# Product Change Notification

## 111762 - 00

**Change Notification #:** 111762 - 00  
**Change Title:** Chassis Electrical Maintenance Kit FUPLESK for Intel® Server Chassis P4000L and Full Length General-Purpose computing on Graphics Processing Units (GPGPU) Support Bracket AUPLGPUBR PCN 111762-00, Product Material Update Power and Serial Cables  
**Date of Publication:** September 21, 2012

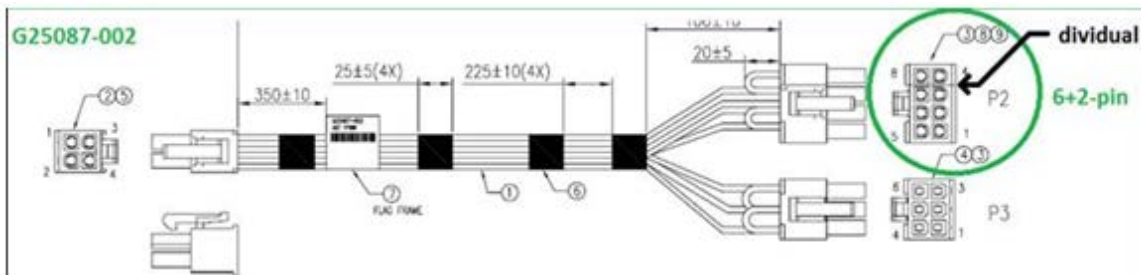
1. Intel ® Chassis Maintenance Kit for P4000L/P4000L-WS (FUPLESK) will have the following updates:
  - a. The Power Cable for the GPGPU will be replaced with a revised version to support a wider range of double width video card power connectors. See pictures below:

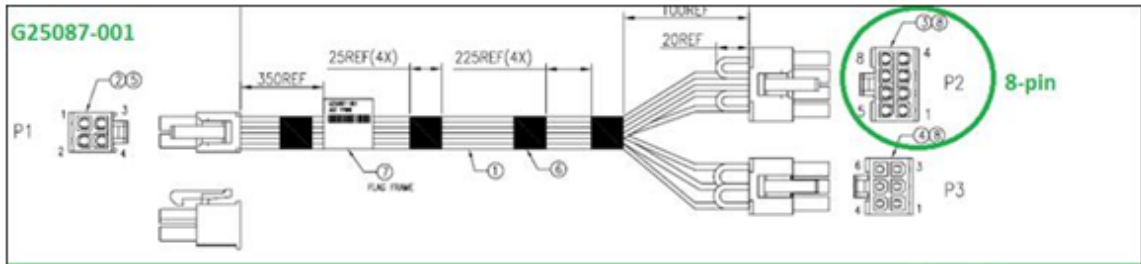
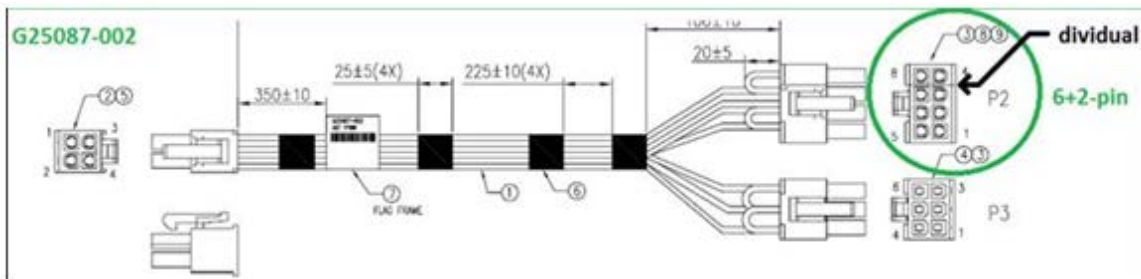
- b. The serial port cable is being extended from 290mm to 390mm to avoid interference on fully populated systems with double width cards.
2. P4000L/P4000L-WS GPGPU card bracket (AUPLGPUBR) is being updated with the new power cable for the GPGPU. See pictures below:
